# Service Kit 753-0642

Code: R-367

Date: September 12, 1995

Subject: Replacement Pivot Bar Ass'y  
Model 400/600/700Series Riders.

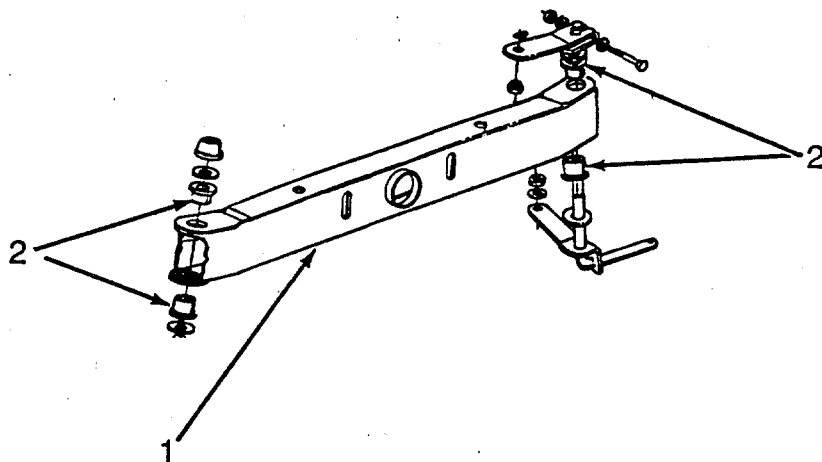
This kit will replace earlier style pivot bar assemblies. The flange bearings (Part No. 741-0487A) used on the 683-0002 pivot bar will not work on the new assemblies. These bearings must be replaced with the new flange bearings provided in the kit.

Service kit 753-0642 is for a new pivot bar on a 600 series machine. It works unless you have a Yardman machine. If that is the case, the person putting on the pivot bar will not be able to get the flange bearings to sit flush on the pivot bar because the end caps, part #731-1291 on the Yardman, get in the way. Make a note in your Yardman illustrated parts that if they use this kit on a Yardman that they need to change the end caps also to a 731-1291A. That'll work.

Ref. No.	Part No.	Description	Quantity
1	683-0128	Pivot bar Ass'y	1
2	741-0659	Flange Brg. .632" I.D.	4
